Homestead off Barker Lane Design and Access
Statement

320110867P

PRE-APP REQUEST REF NO RV\2011\ENQ\00286

Figure 2- showing reduction in floor plate further to L.A. comment

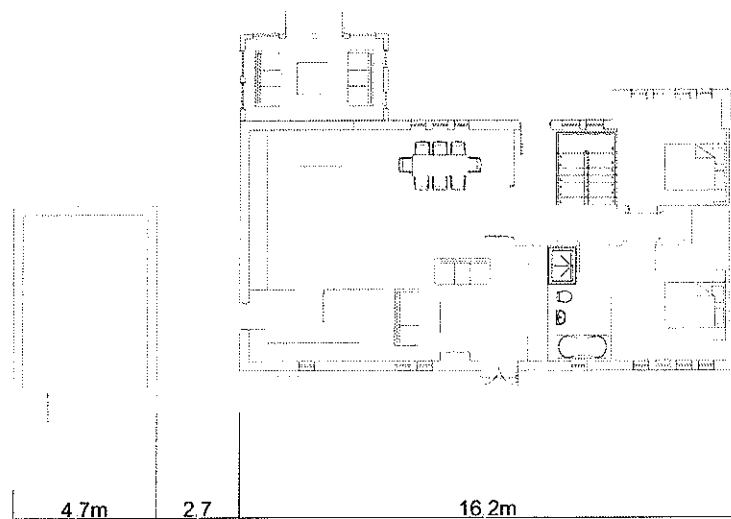
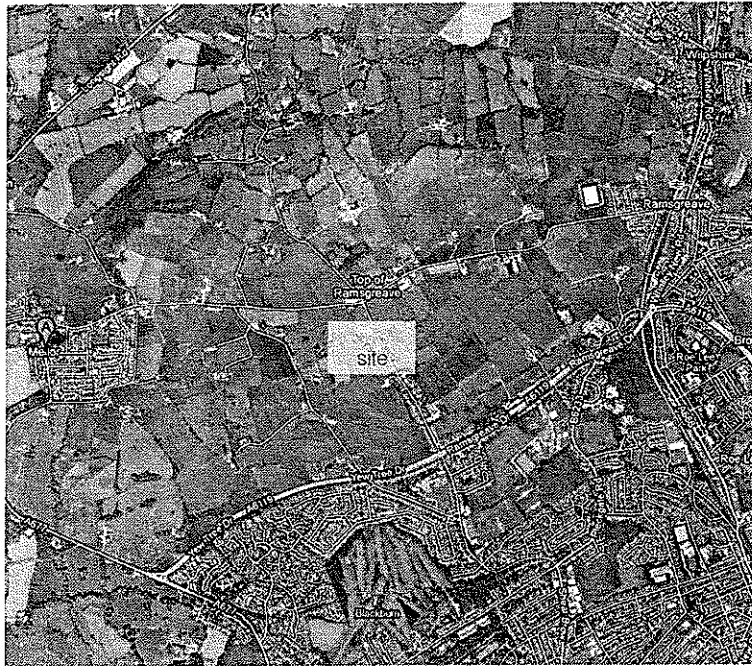
- 1 1 1 The proposal submitted with your pre-app shows a slight increase in height from that previously approved, as well as a change in shape (effectively changing from an L shape to a rectangle) involving the widening of the dwelling and the creation of a separate detached garage

- 1 1 2 In doing this, the existing gap on site between the adjacent property known as Sunnyside is reduced significantly and this is considered to have an impact on the openness of the Green Belt at this location

- 1 1 3 As such, I would recommend that the height of your proposed dwelling be no more than that approved (6.6m max.) and the width of the dwelling be reduced by a minimum of 2m, and with regards to the garage, be either removed altogether or significantly reduced in height (perhaps by lowering the ground level?). The reason for this being to protect the open aspect through the site that is currently provided on site.

Fig 2 page 6 show that further to Local Authority comment the footprint has been reduced in width by 1.3m (see fig 1 overleaf); the design, water harvesting system and efficiency of photovoltaic's would be severely compromised if the footprint was reduced further

PA02 rev B Tabled on 25.08.11

PA02 rev C Updated further to Local Authority comments made on 25.08.11

Figure 4 – Proposed Site Layout

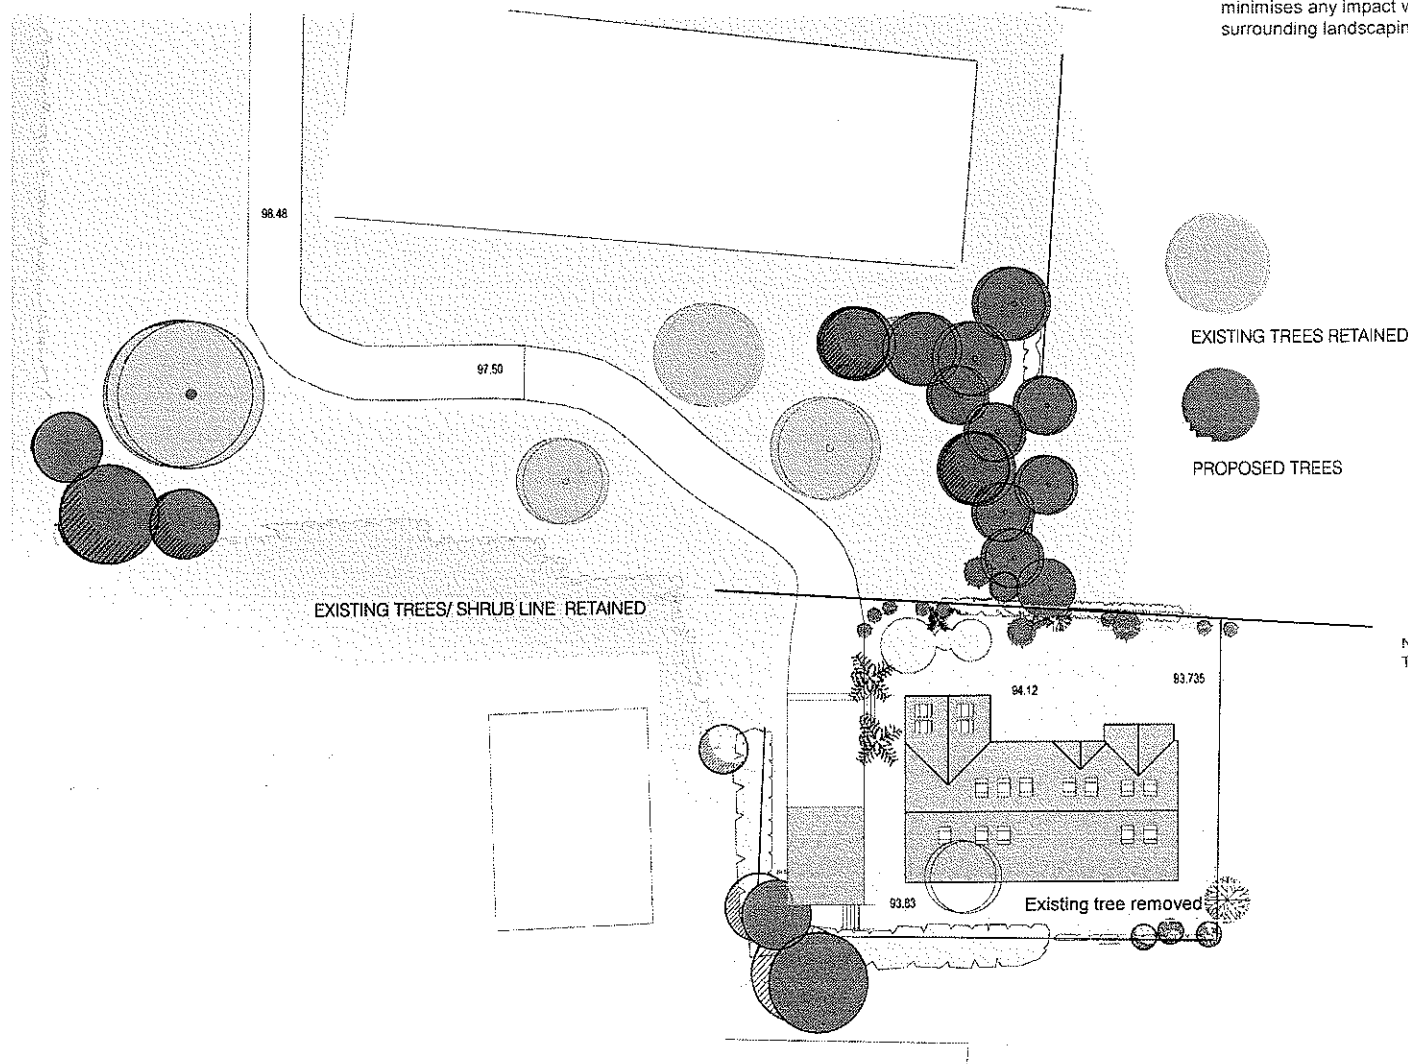
- 1 1 5 With regards to the revised access track. I have no specific objections. However, please note this land IS outside the residential curtilage of Homestead and the Council would not support the formal inclusion of it within the residential curtilage

The access road has been remodelled/ repositioned to prevent light from vehicles interrupting the privacy of the immediate neighbours on the eastern boundary. The drive has been lowered and moved away from this neighbouring property further to discussions with the resident

Much of the existing landscape is retained as part of the proposal. One tree is proposed to be felled (as identified on fig 4) and unmaintained shrubs will be lopped in order to enhance and define the area of green belt
